Craig 9 Ranches Master Drainage Study

CITY OF LAS VEGAS		DATE:
INTER-OFFICE MEMORANDUM		October 27, 2016
TO: Land Development Services Department of Building & Safety		FROM: Albert Sung, P.E. Flood Control Project Engineer Department of Public Works
SUBJECT:	Drainage Study for:	COPIES TO:
	Craig & Rancho Master Drainage Study	Lochsa Engineering
Cross Streets:	SEC of Craig Road & Rancho Drive	Pre Rancho Craig LLC
File Number:	F:\Depot\DSMemos\DS4824B.doc	Bart Anderson, P.E., DevCo
Parcel Number:	138-02-713-002	CCRFCFCD
Zoning Action:	N/A	NDOT
FEMA Flood Zone	YES NO X	
Proposed Storm Drain	YES NO X

**DISTRICT CONCURRENCE: CRAIG & RANCHO MASTER DRAINAGE STUDY
(DS4824B) (RFCD No. 16-9754)**

Subject: Addendum to Craig & Rancho Master Drainage Study
City of Las Vegas DS4824
Lochsa Engineering Project Number: 161051

SHEET No.: C3.01
SHEET 6 OF 9
CLV No. 65704

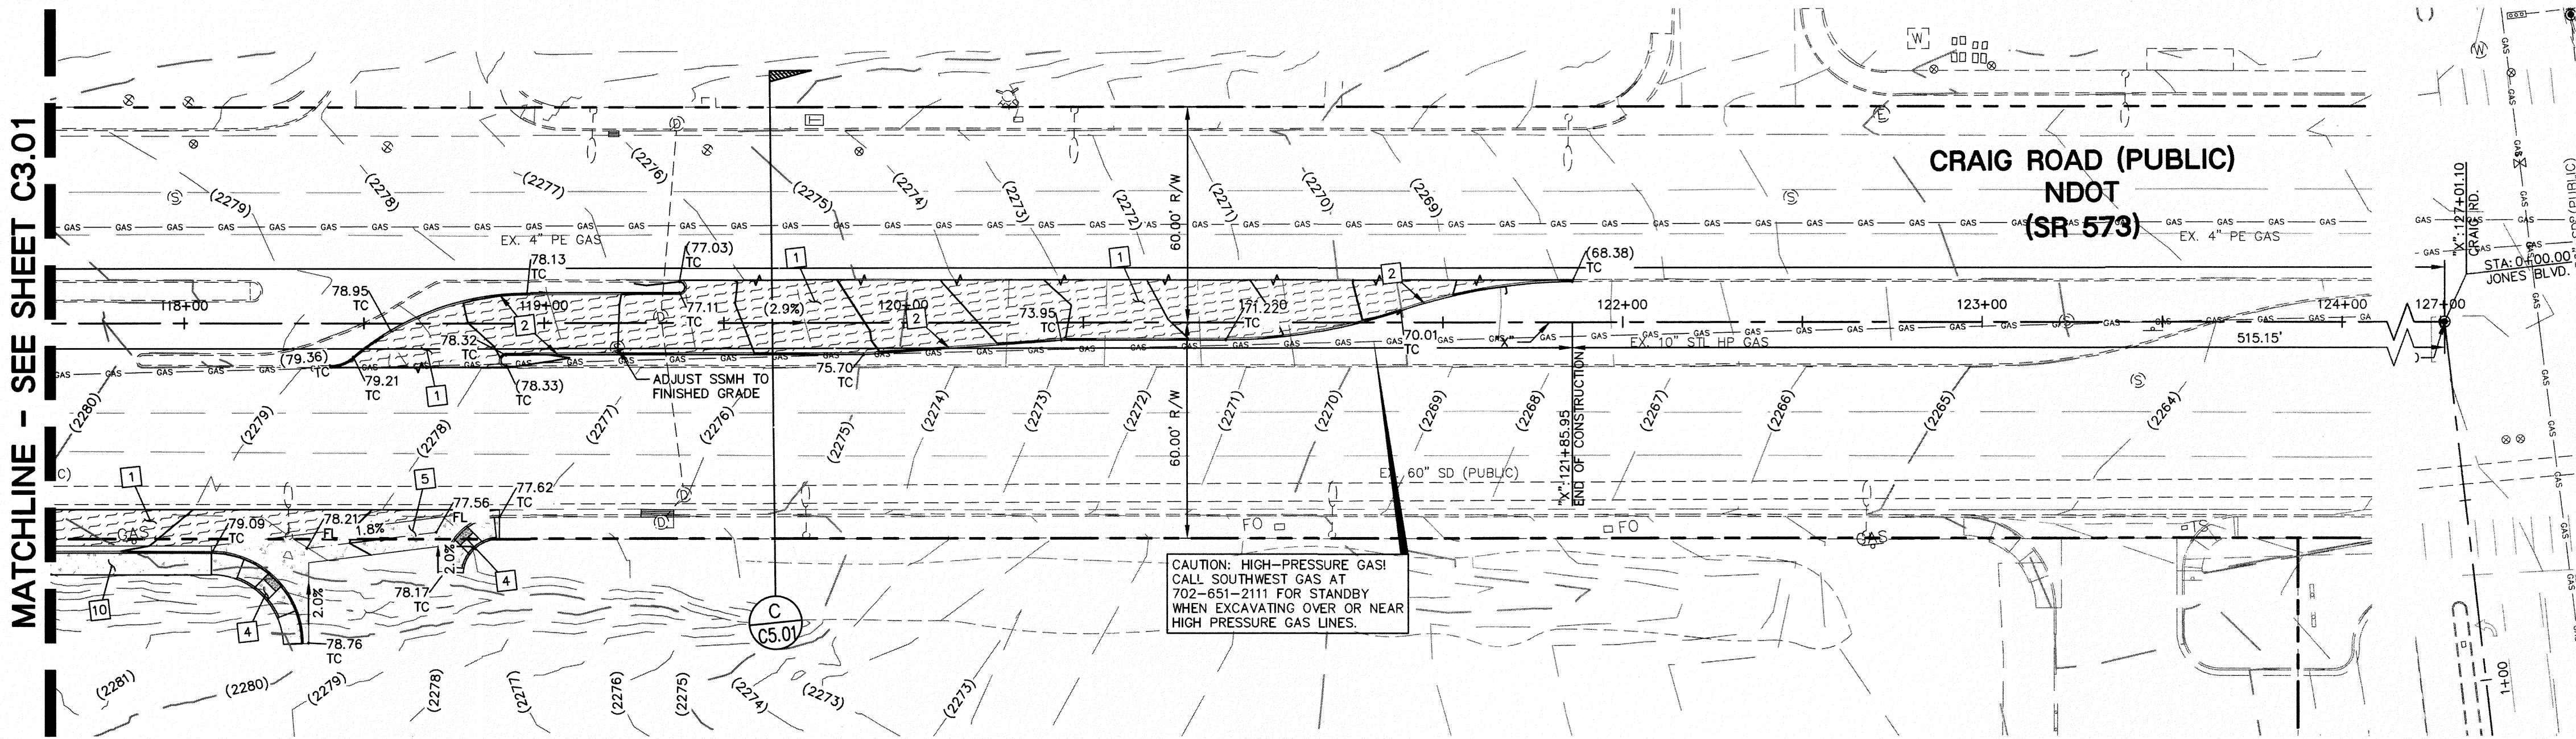
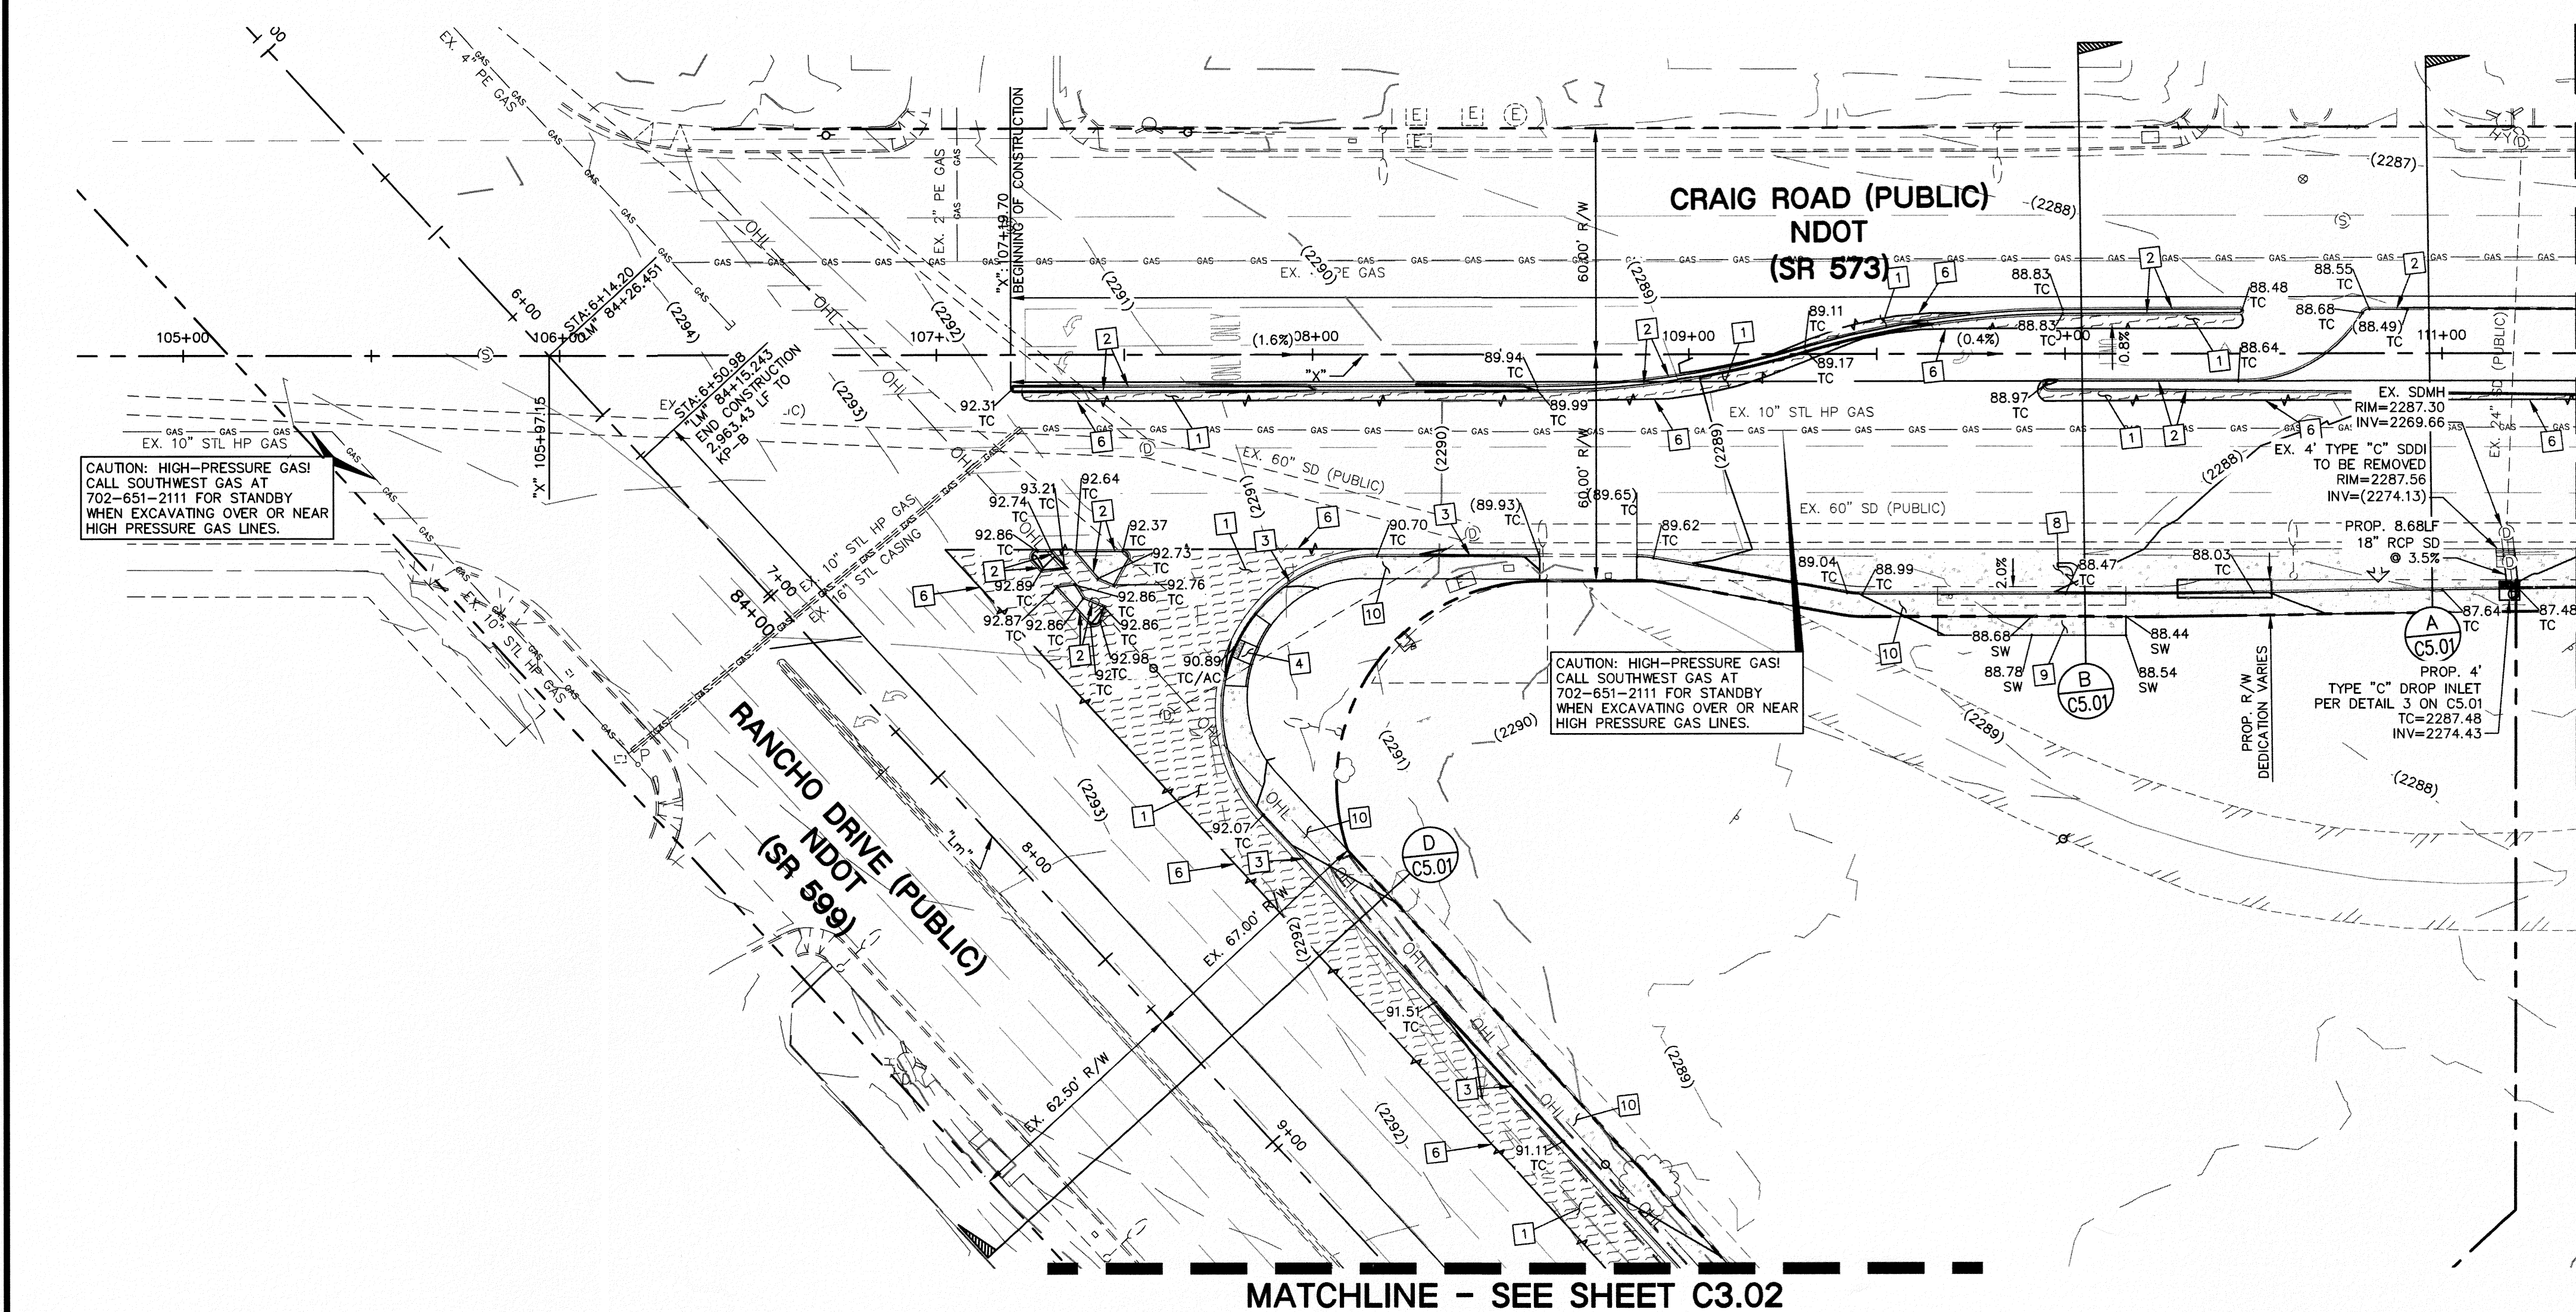
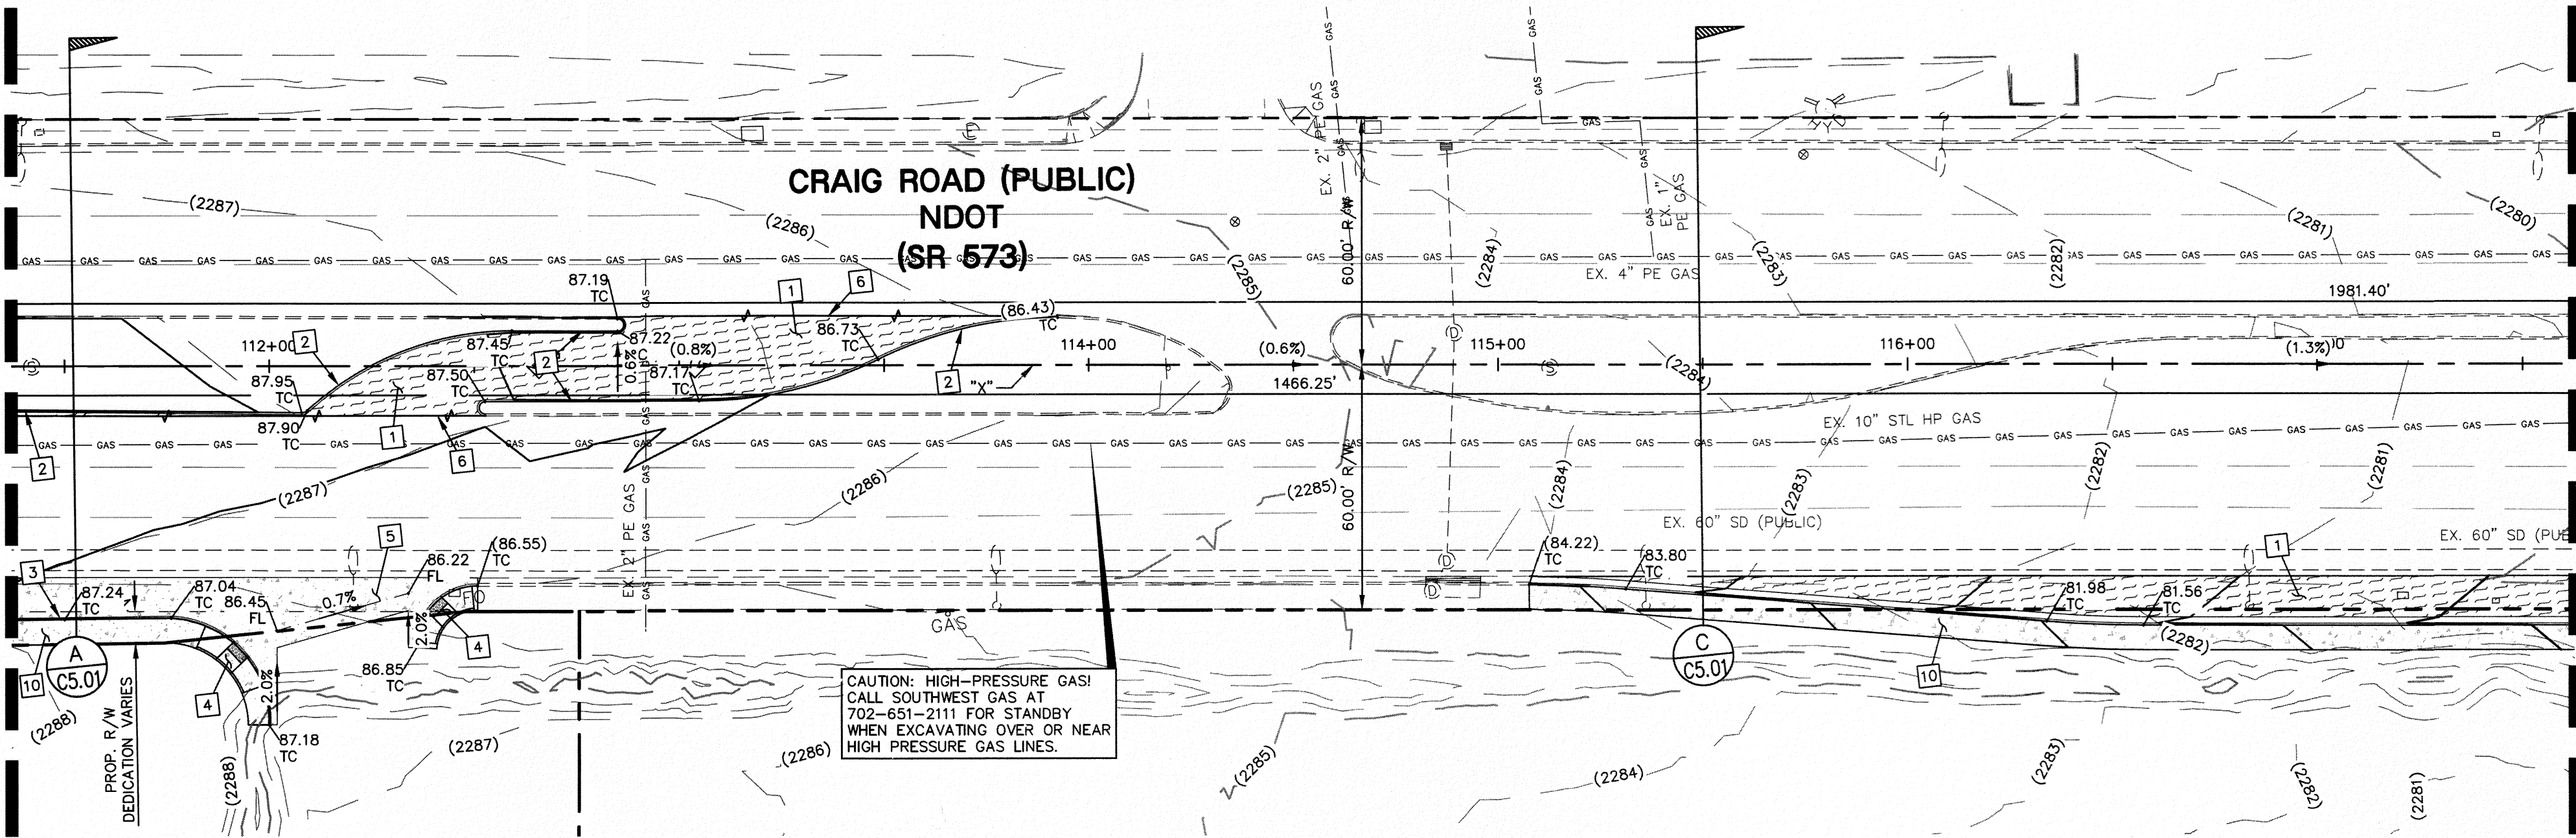
4. **Sheet C3.01:** Upsize the proposed 18"-lateral to 24"-diameter at the relocated drop inlet near Station 111+00 in *Craig Road*.

Response 6: The grading plans for the proposed improvements within Craig Road and Rancho Drive are being submitted with this Addendum. As shown in Sheet C3.01, the improvements to Craig Road are limited to reconfiguration to portion of the existing median and the intersection, additional left-turn through the existing median, and additional turn-right lane. Normal depth calculations were previously provided for the south half of Craig Road at Sections CC and DD. Since the proposed median reconfiguration remain within the existing median, and due to the limited flows conveyed at Sections CC and DD, the previously submitted normal depth calculations represent the existing and proposed conditions.

To accommodate the proposed right-turn lane, the existing 4ft Type C drop inlet near Station 111+00 is relocated to the proposed curb. The existing 18" RCP lateral is extended to the proposed drop inlet location. The previously submitted referenced information for Craig Road storm drain is being resubmitted with this Addendum. As shown in the attached referenced information, the drop inlet was labeled as Drop Inlet (D.I.) #11A in the as-built plans for Craig Road. Due to the minor flows intercepted through D.I. #11A, the referenced Craig Road design information did not include hydraulic capacity calculation for the drop inlet. However, utilizing the same referenced design approach and referenced hydraulic parameters (i.e. street flow depth and slope) from D.I. #13 (approximately 400ft downstream D.I. #11A), illustrates approximately 5.50cfs may be intercepted through D.I. #11A. An inlet-control nomograph is provided with this Addendum to illustrate the sufficient capacity of the existing and extended 18"RCP lateral.
